METROPOLITAN GOVERNMENT OF NASHVILLE AND DAVIDSON COUNTY

STAFF RECOMMENDATION
3703 Meadowbrook Avenue
October 17, 2012

Application: New construction-addition and Ridge raise
District: Richland-West End Neighborhood Conservation Zoning Overlay
Council District: 24
Map and Parcel Number: 10405020500
Applicant: Brad Skipper, contractor
Project Lead: Robin Zeigler, robin.zeigler@nashville.gov

RIGHT ELEVATION

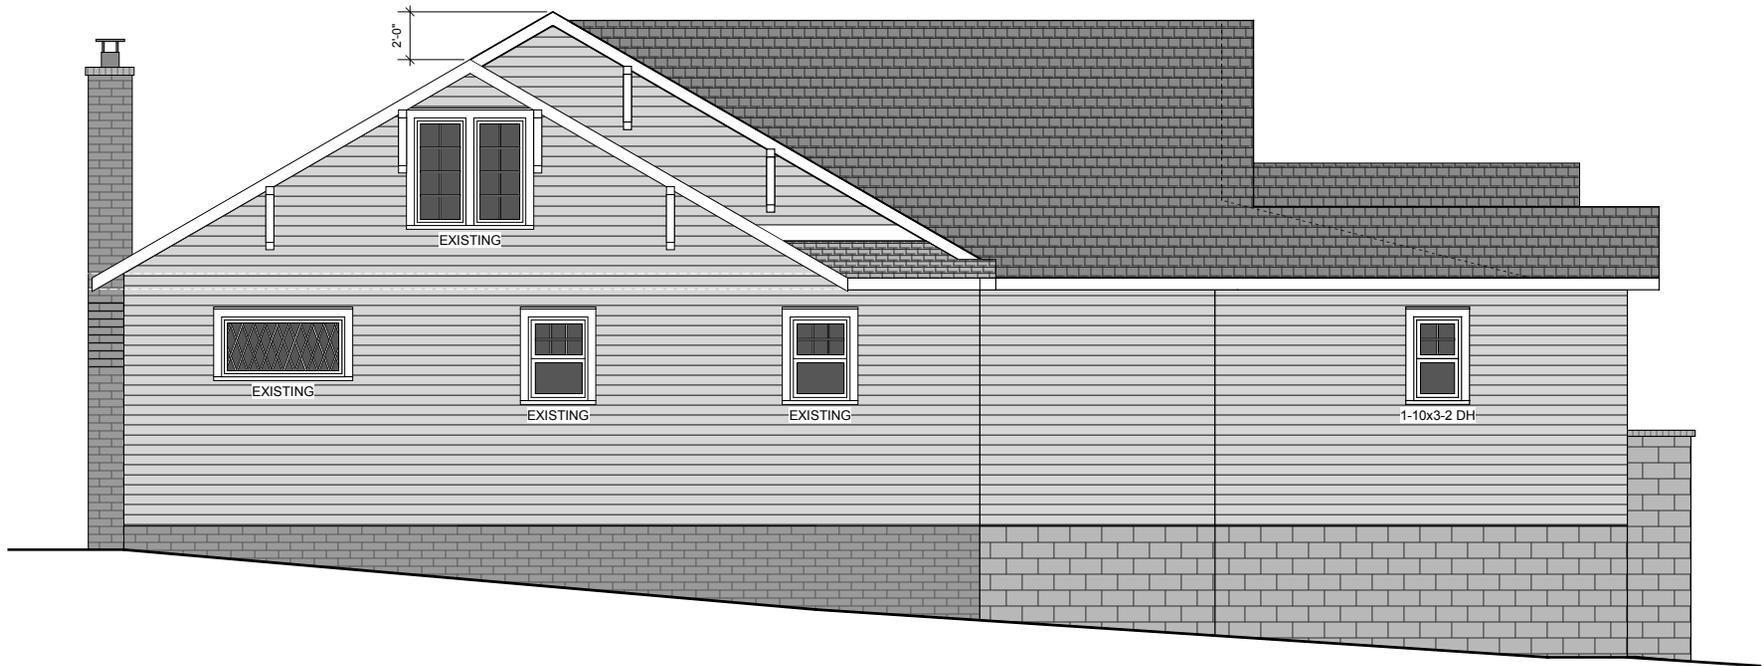
Proportion and Rhythm of Openings: The greatest expanse of wall without an opening is on the right side and is approximately twenty-three linear feet. Because this area will be minimally visible from the street and is broken up with a ten foot (10') inset, staff finds the rhythm to be appropriate. The project meets section II.B.g of the design guidelines.
